Access Compliance Report

Public Rights-of-Way

(Curb Ramps)

Intersection ID: 15459	Main Street: CONISTON_PL	Cross Street: S_KINGS_DR	Location: SE
ADA ID: FFA5BFA87B92	Ramp Type: Directional1	Initial Pass/Fail: Pass	Overall Compliance: No
Severity Score: 0.25			
Codes/Mitigation Info/Possible Solution		Field Measurements/Component Compliance

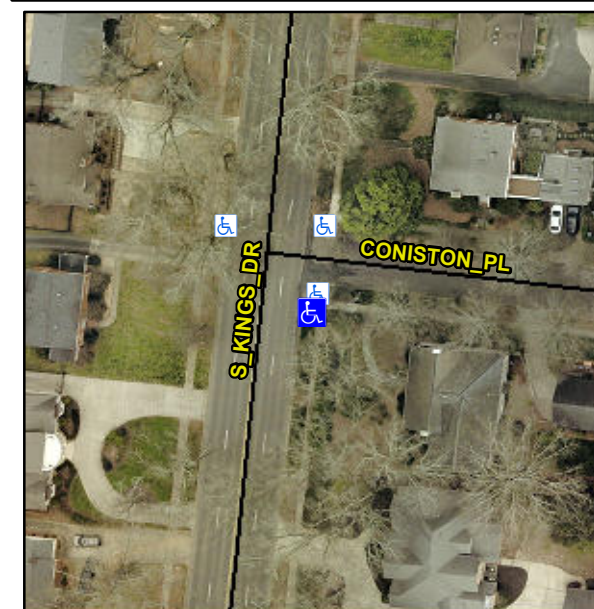
**Remove & Replace Entire Ramp.
Gutter Ponding Observed.**

R304.5.3, R304.5.2, R302.7
